**REDSTONE GATEWAY PACKAGE 1F-REDSTONE GATEWAY
EXTENSION, MARKET STREET, AND OVERLOOK ROAD
RELOCATION**

**Project No. 65-11-SP22
October 4, 2011**

Addendum #2

GRADING AND STORM DRAINAGE PLAN
REDSTONE GATEWAY - PACKAGE 1B - ROADWAY AND UTILITIES
CITY OF HUNTSVILLE
HUNTSVILLE, ALABAMA

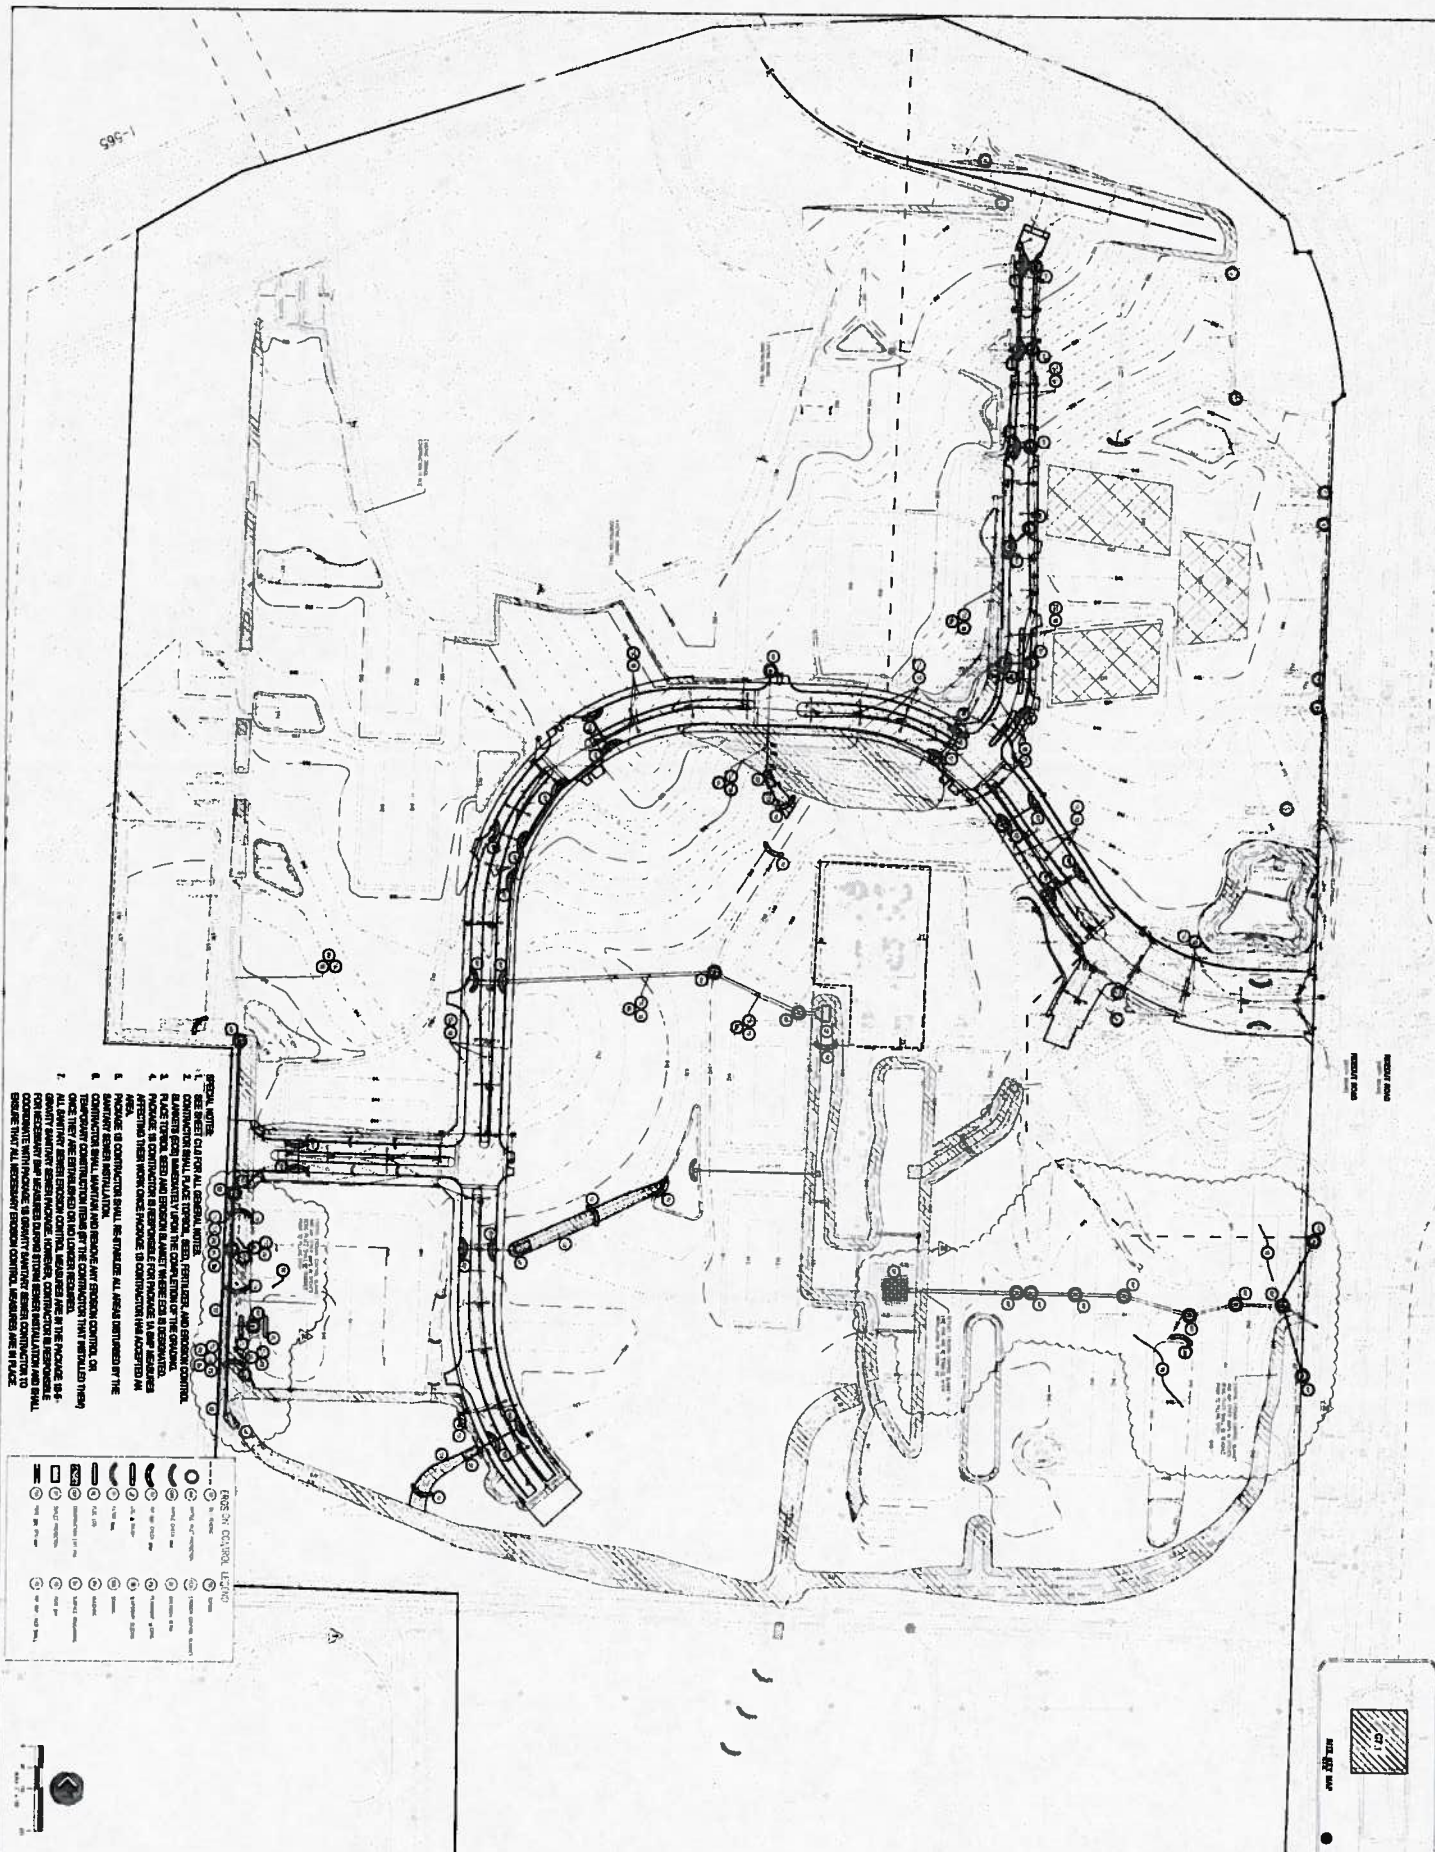
17. **Q.** Has any additional grading, drainage, erosion control, or utility work been added to the site along the western boundary and through the retail site noted as Area 1?

A. Yes, refer to the Package 1B - Revision 2 drawings in this addendum, in particular the clouded areas noted on Sheet C6.0, C7.1, C8.1B, C11.2, and C15.0. Below is a summary of the new Package 1F-1 scope of work (note that the items listed below are currently shown in the 1F-1 drawings as existing - issued for bid drawings will merge these two drawings sets together into one overall set of drawings for ease of construction):

<u>Sheets</u>	<u>New Package 1F-1 Scope of Work</u>
C6.0	Grading around inlets and ditch line adjacent to Rideout Road and along the western boundary line. Storm Line S-1, S-2, & S-3 (Line S-4 to S-5 is a part of Package 1B), U, V, W, and X.
C7.1	Erosion Control
C8.1B	Water main relocations due to storm lines V, W, and X.
C11.2	Details
C15.0	Storm Profiles

Typical Utility Placement Cross Section

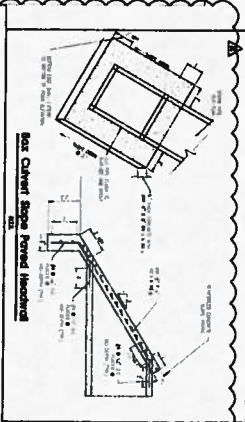
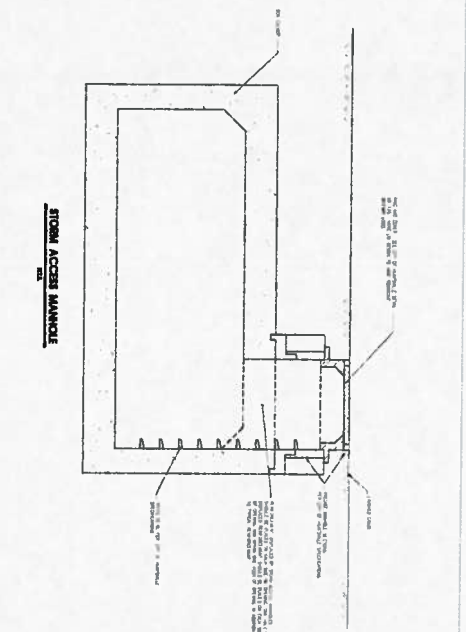
10. **Q.** Is the Redstone Gateway Package 1F-1 responsible for the Lighting conduit in the median as shown on sheet 14.4 (Utility Placement Cross Section)?

A. No, but the 1F-1 contractor shall coordinate this work with the 1F-4 contractor as it relates to curb and paving installation.
11. **Q.** How much bedding and stone backfill is required around the box culverts in improved and unimproved areas?
